**SUBJECT:** **New Vehicle Demo/Delivery Hold - Safety Recall 24S06 – Supplement #1**

Certain 2018-2020 Model Year Ford Expedition and  
 Lincoln Navigator Vehicles  
 Inadvertent Retractor Pretensioner Deployment

**New! REASON FOR THIS SUPPLEMENT**

FIGURE 19

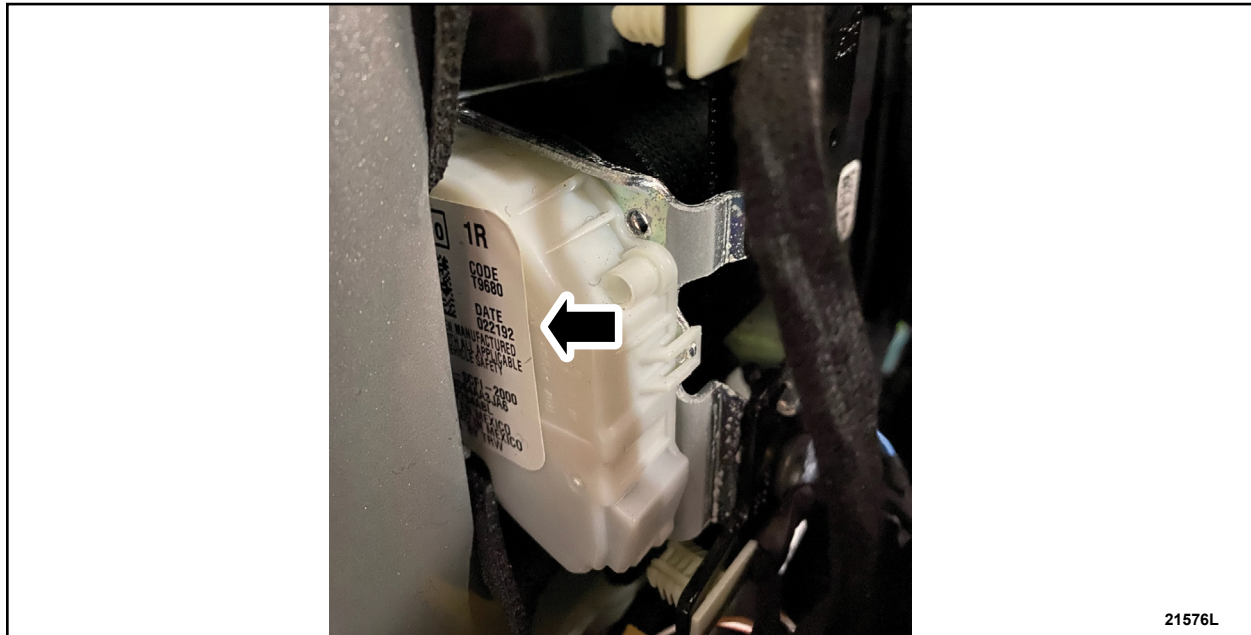
12. Locate the part label sticker on the back of the Left-Hand (LH) and Right-Hand (RH) front seatbelt retractors. See Figure 19.

FIGURE 20

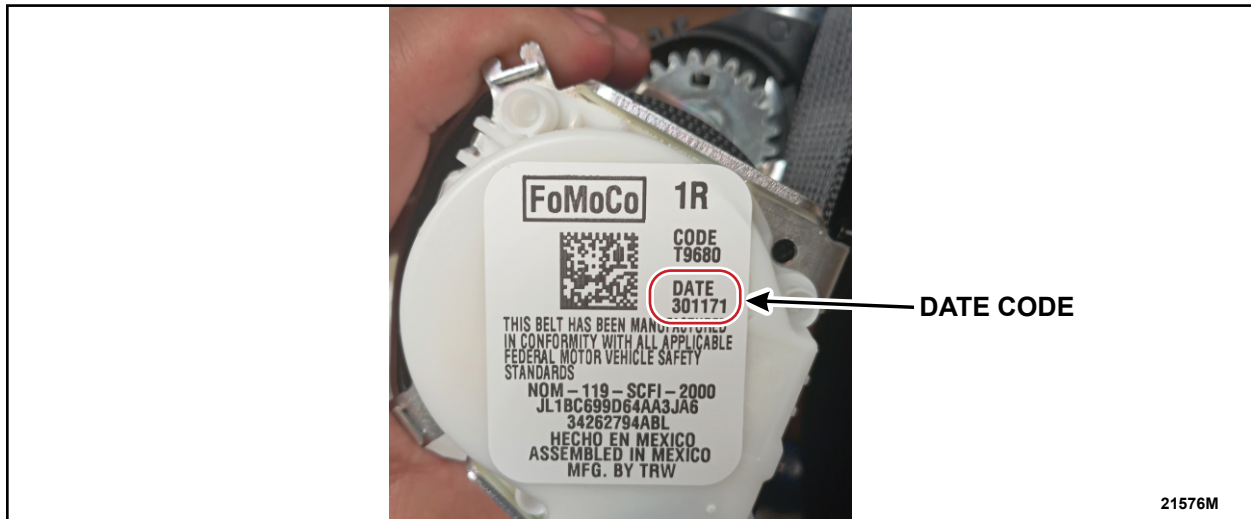
13. Locate the date code on both the LH and RH front seatbelt retractors. See Figure 20.

14. Do either the LH or RH front seatbelt retractor date codes match any of the following date codes listed in the chart below?

**NOTE: The 3rd digit and the 6th digit of the date codes do NOT need to match.**

Yes - Replace the front seatbelt retractor(s) that have the suspect date codes. Follow the WSM procedures in Section 501-20A.

No - Replacement is not needed. Reinstall the lower B-pillar trim panels by reversing steps 1 through 10, then continue to step 15.
